Thank you for purchasing the PG-FP5 flash memory programmer.

This document describes specifications that have been added or changed, restrictions, and cautions on using the PG-FP5. Also see the user's manual of the PG-FP5 for terminology and points for caution on using the PG-FP5.

## Chapter 2 Additions and Changes to Specifications

#### No. 15 Addition of **Wide Voltage mode** function

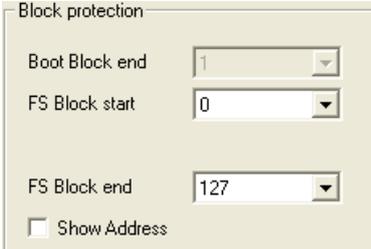
**Description:** The **Wide Voltage mode** check box has been added to the **Command options** area. If this check box is selected, commands are executed in the wide voltage mode. If this check box is not selected, commands are executed in the full-speed mode. This check box is available when a device supporting this function is selected. For details about the wide voltage mode and full-speed mode, see the user's manual of each device.

#### No. 16 Change of layout in **Block protection** area

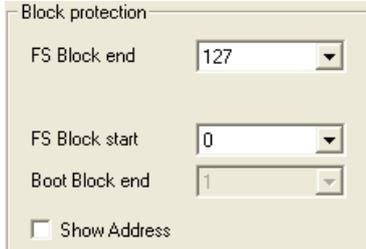
**Description:** The layout in the **Block protection** area has been changed.
